**PRODUCT DFM REPORT**  
(产品结构评审)

Project Name (项目名称):	Handle Tablet	Checked By (审核):	杨金坡
Project Manager (项目经理):	邱振彬	Date (日期):	2017-02-24
Mobile (电话):	--	Website (网址):	www.bestcreating.com
Email (邮箱):	--	Version (版本):	V0.1

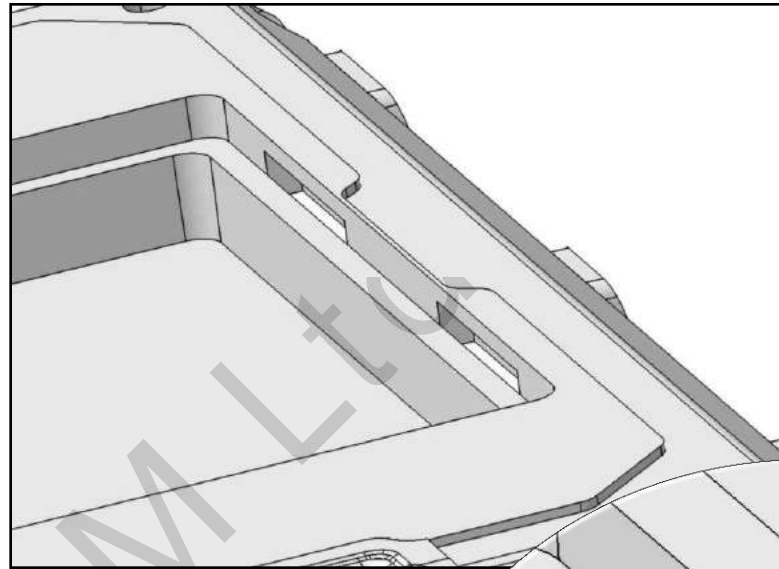
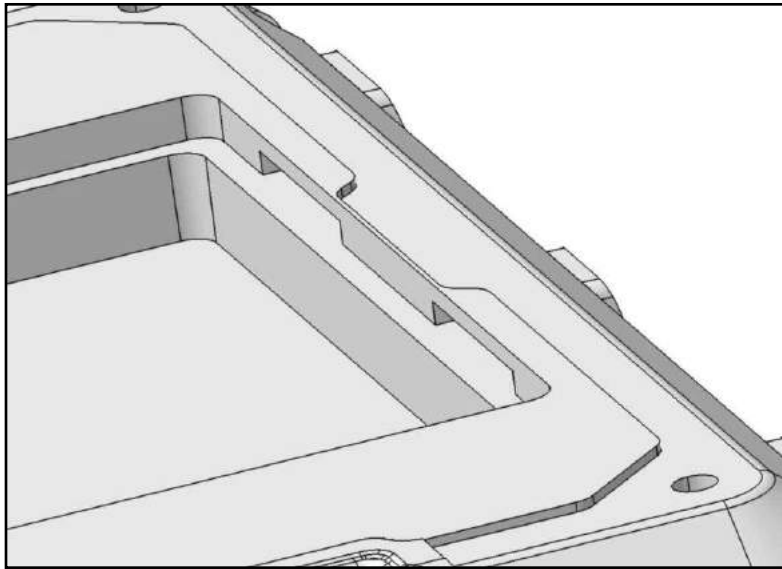
Here are the slight undercut.  
Please modify the drawing.

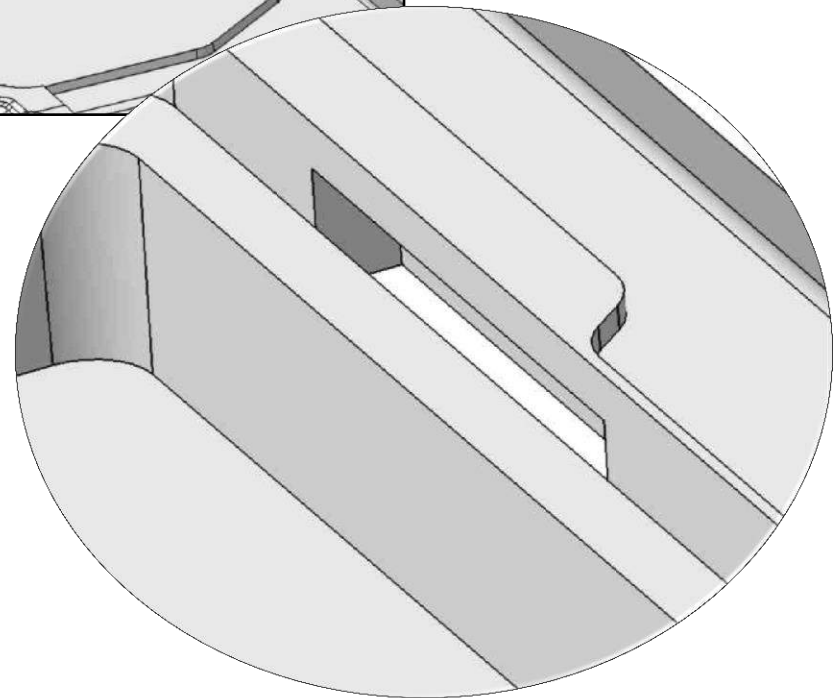
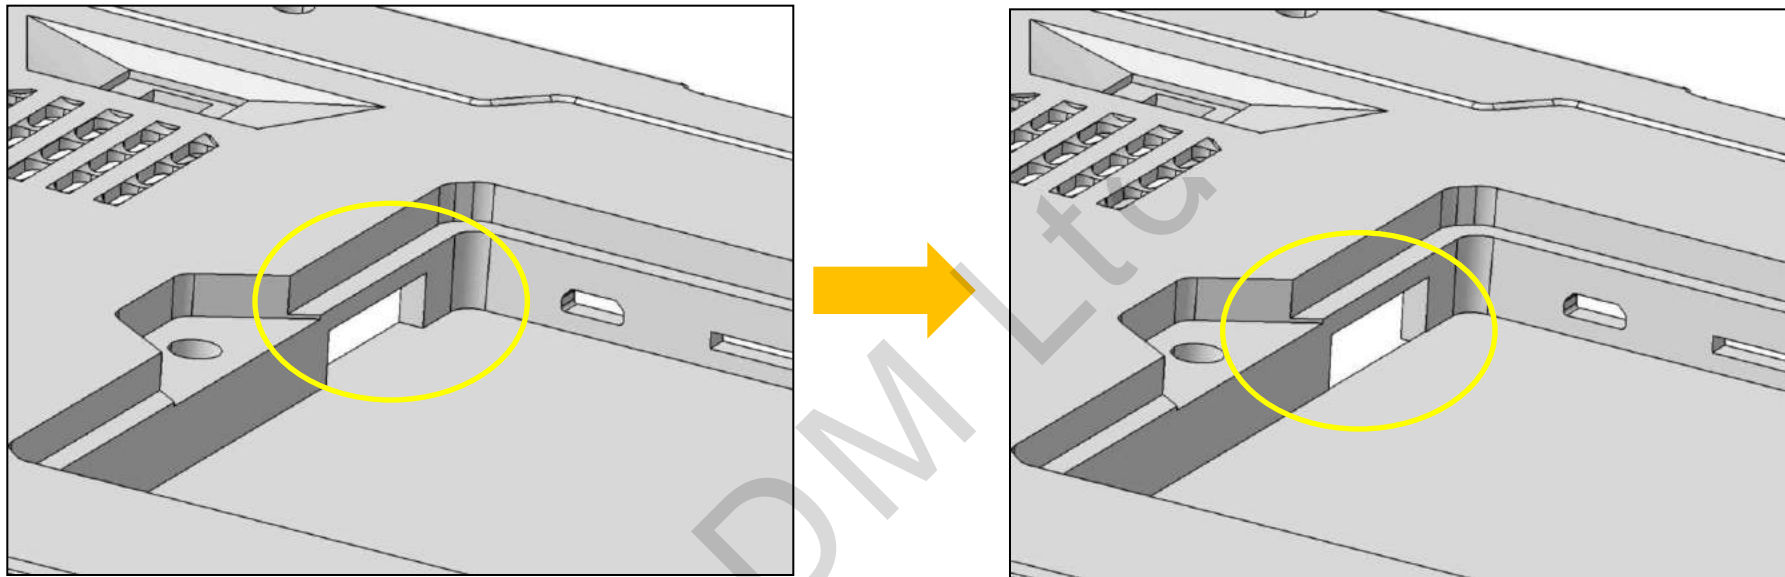
Suggest to change like this to avoid the angle lifter action.  
Is this ok?

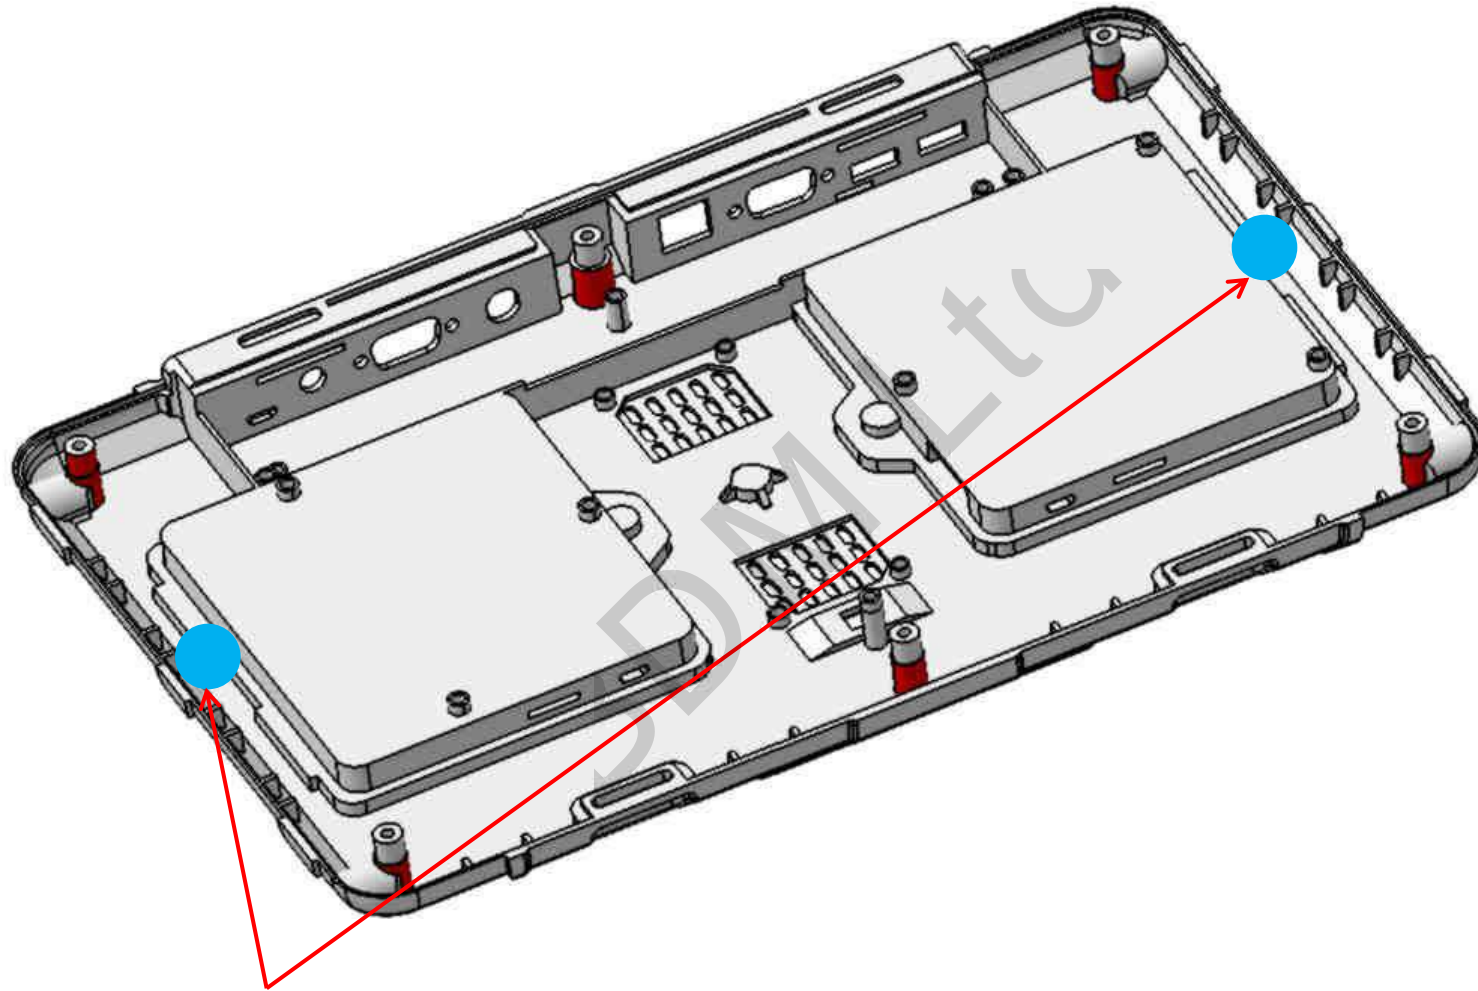
Suggest to change like this to avoid the angle lifter action. Is this ok?

Is it possible to add 2 more screws?

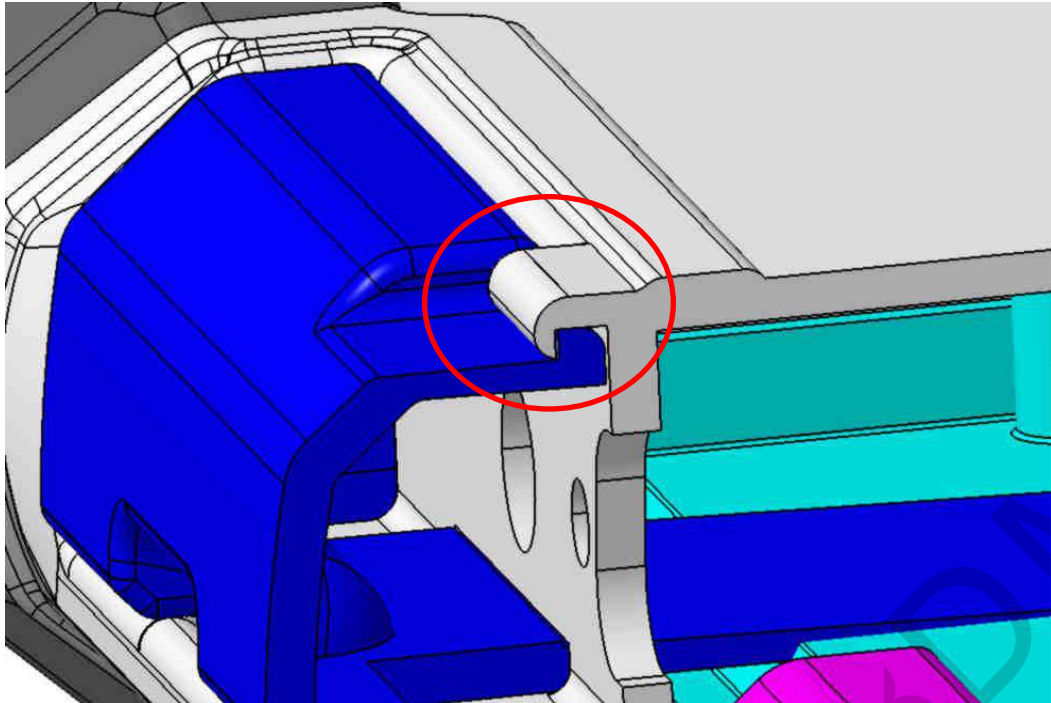
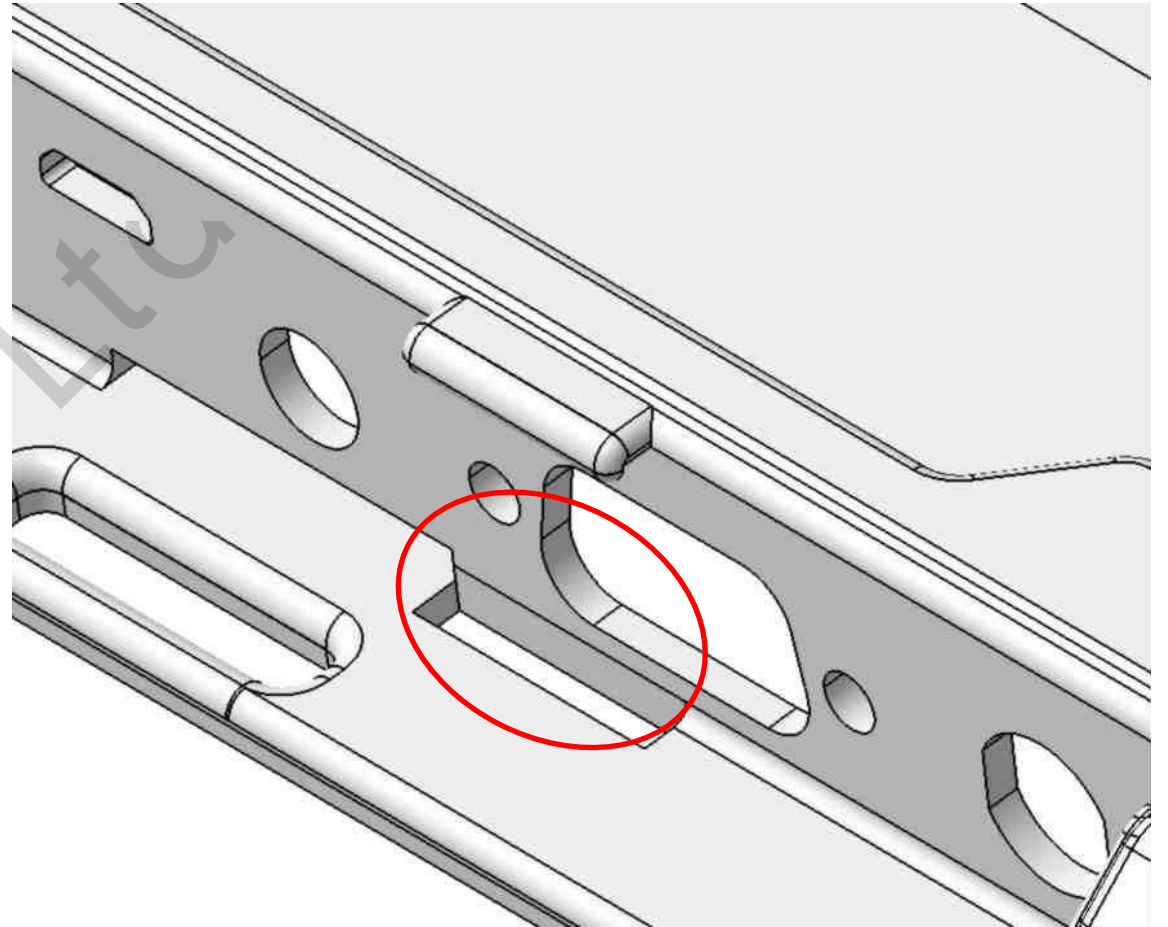
The snap here is not available when molding. See next page.

We advise to make a hole at the bottom

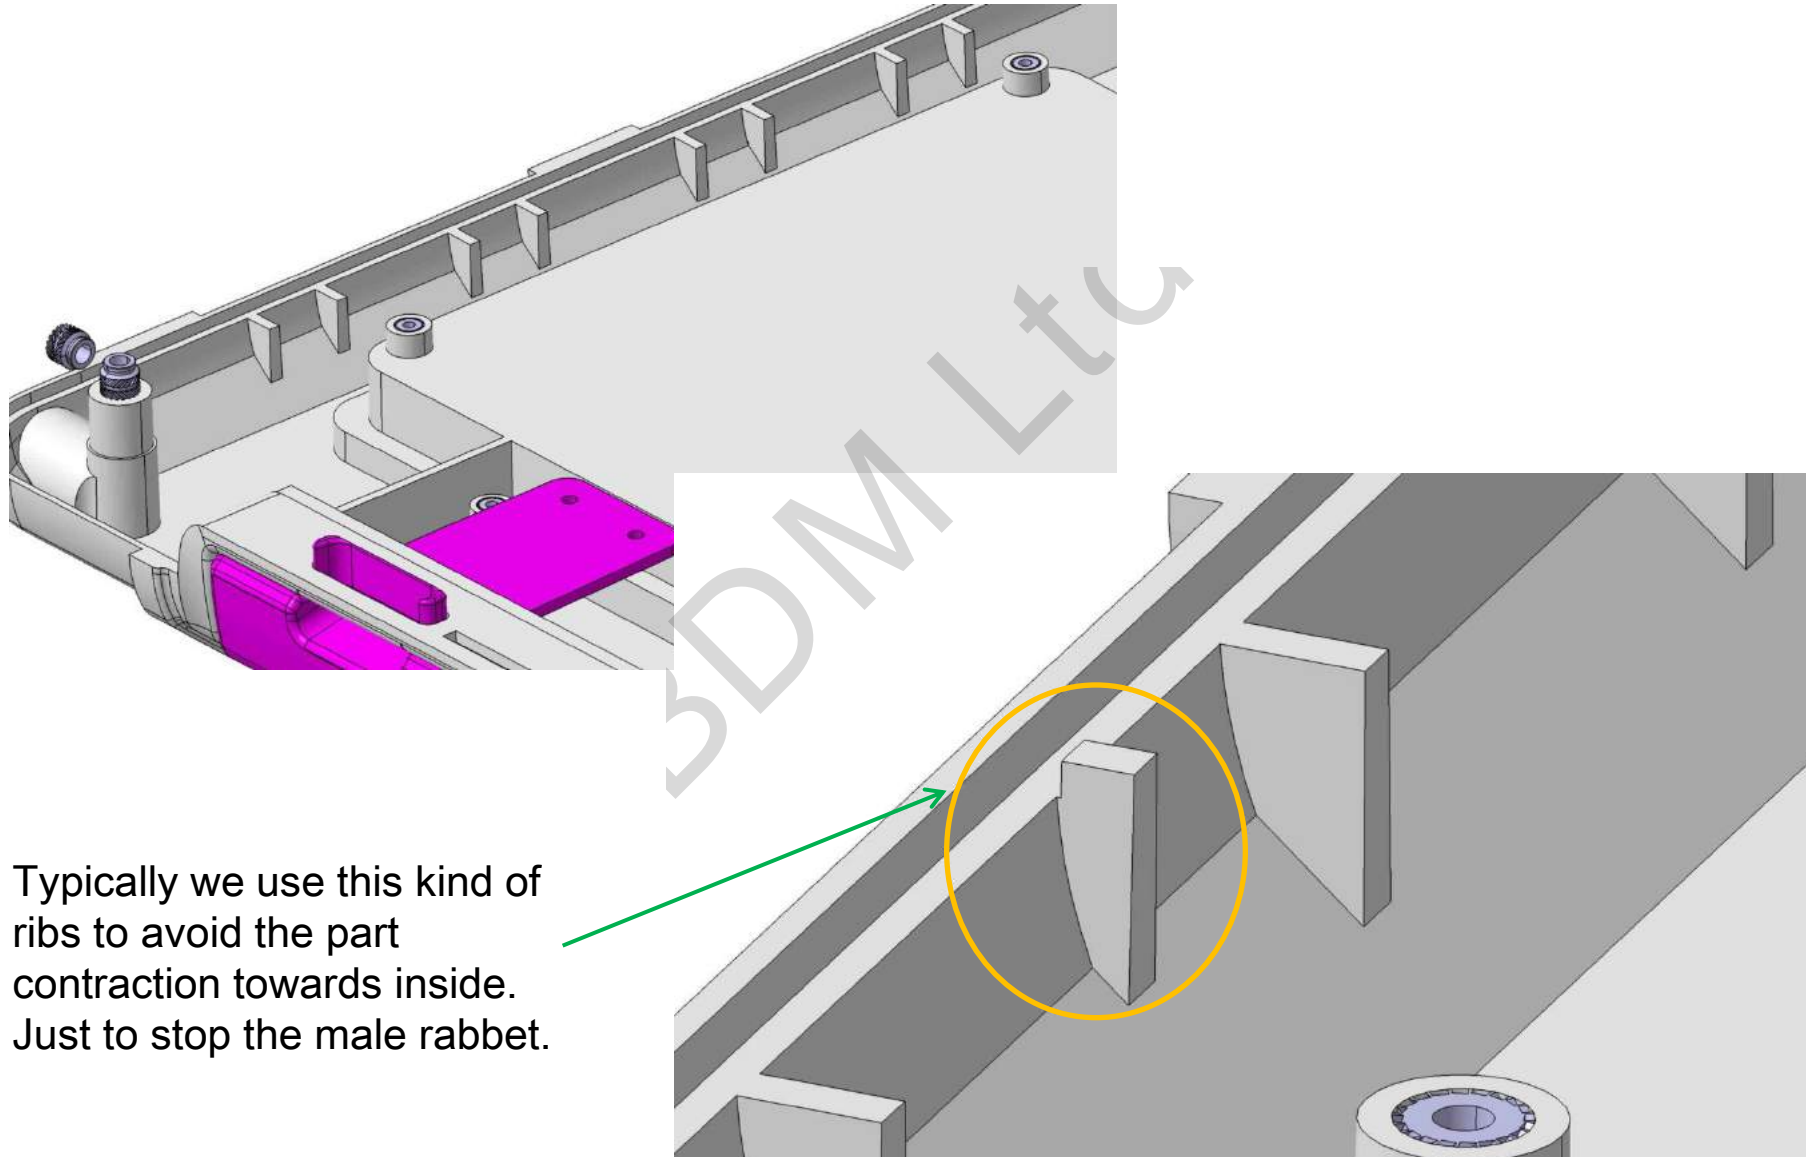
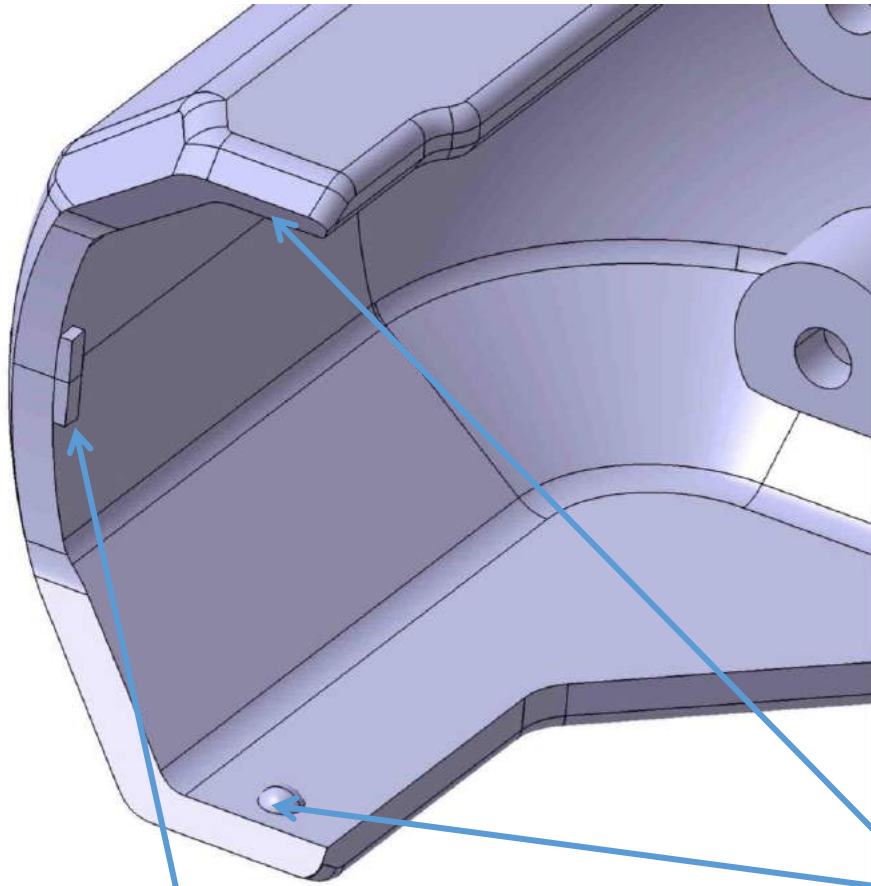
Typically we use this kind of ribs to avoid the part contraction towards inside. Just to stop the male rabbet.

Add the rib to help to hold it in place.

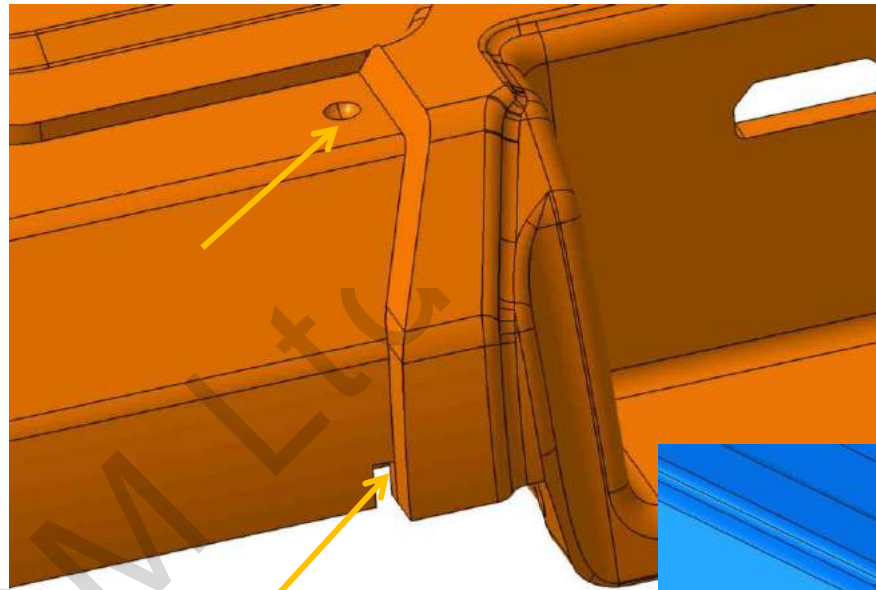
Add some glue on the dots to help to hold the TPE.

Modification in turr  
Is this ok?

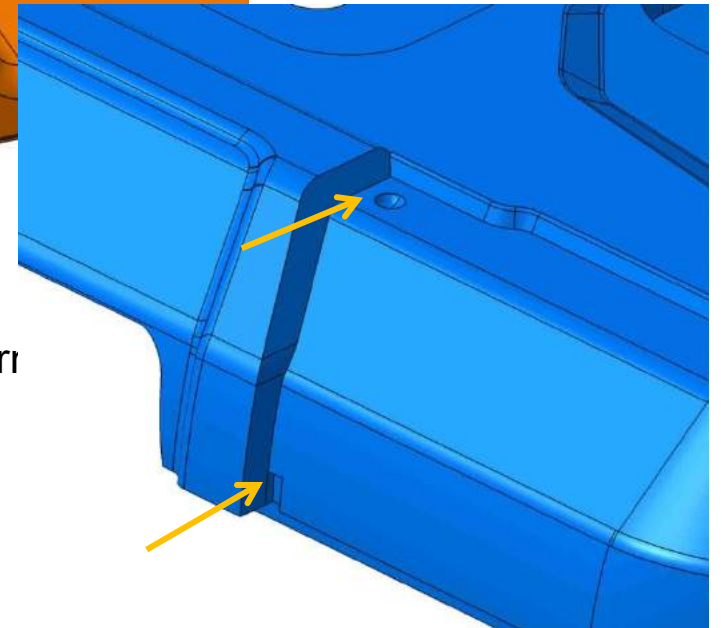
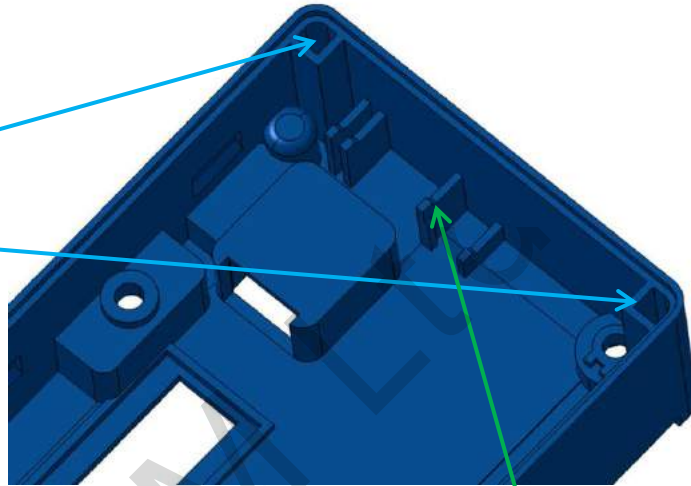
This design will lead to a separate steel in the mold, can you change the design to avoid it?
